RE: Penrith City Park, Penrith – Traffic Management Advice

P1311I01v4_TS, Penrith City Park, Issue IV

Figure 2: Proposed Draft Concept Design by Penrith City Council

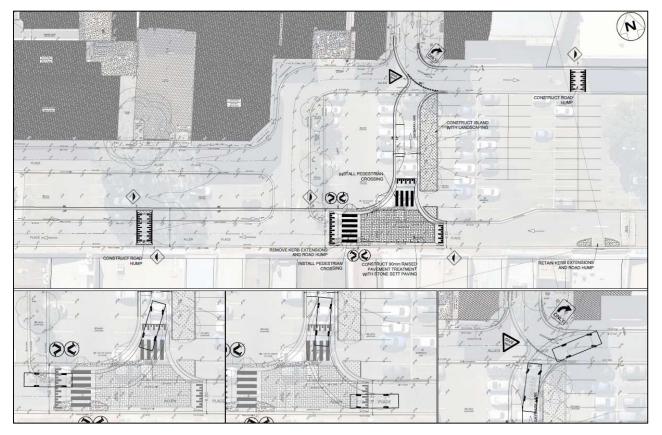
This Transport Statement (TS) provides our initial design advice and comments in relation to Council's draft concept plan issued to Ason Group via email of 6 May 2020 and shown in **Figure 2** and subsequent changes that have been agreed to.

As per Council's plan, a width of 9.1 metres would be provided for Allen Place and 6.0 metres for new oneway northbound street. The proposed widths have been assessed against the requirements set out in Table C10.1 of Council's DCP, replicated below for reference:

Based on the controls stipulated in Council's DCP, both Allen Place and Gaymark Lane would fall under the category of a 'Local Road' which is defined as a road or street used primarily for property access. Local roads include laneways, access ways and rural residential roads for lots typically less than or equal to 1 hectare. With consideration to Table C10.1, the proposed widths are consistent with the requirements of Council's DCP.

Furthermore, having consideration for the traffic volume data provided by Council, which indicates that these streets accommodate relatively low volumes of traffic, the proposed widths are compliant with Austroads *Guide to Road Design – Part 3: Geometric Design*, which recommends widths of 3.0m - 3.3 metres per travel lane in low-speed urban environments with low truck movements (as is assumed to be the case).

Therefore, the proposed road widths of Allen Place and Gaymark Lane are supportable from a geometric design perspective. Moreover, there is opportunity to investigate the provision of other facilities such as bicycle lanes.

Pedestrian (zebra) crossings are proposed as part of Council's concept plan, at the newly formed intersection of Allen Place and Gaymark Lane. It is proposed to install a zebra crossing on Gaymark Lane and another on Allen Place (western leg). It is important to note however, that Transport for New South Wales (TfNSW) specify warrants in the Supplement to Austroads Guide to Traffic Management Part 10 (Version 3.0) which need to be satisfied prior to installation of zebra crossings.

Whilst pedestrian flow data is not available, and is expected to change as a result of the development of the Penrith City Park, the vehicle flows are expected to fall below and not meet the warrants which requires PV to be greater than or equal to 60,000 in each of three separate one hour periods in a typical day; therefore, TfNSW may not approve the proposed pedestrian crossings.

With consideration to the above, the requirements for a Special Warrant can be satisfied quantitatively.

The provision of 2 x zebra crossing on Gaymark Lane and Allen Place (western leg) is therefore supportable from a traffic perspective.

Figure 3: Updated Concept Design – 2 November 2020

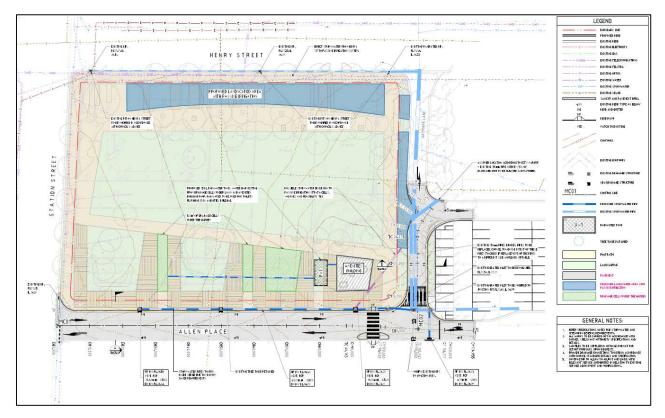
Furthermore, an updated plan was submitted to Ason Group via email on 2 November 2020, shown in **Figure 3**. This TS also provides design advice based on the latest concept design.
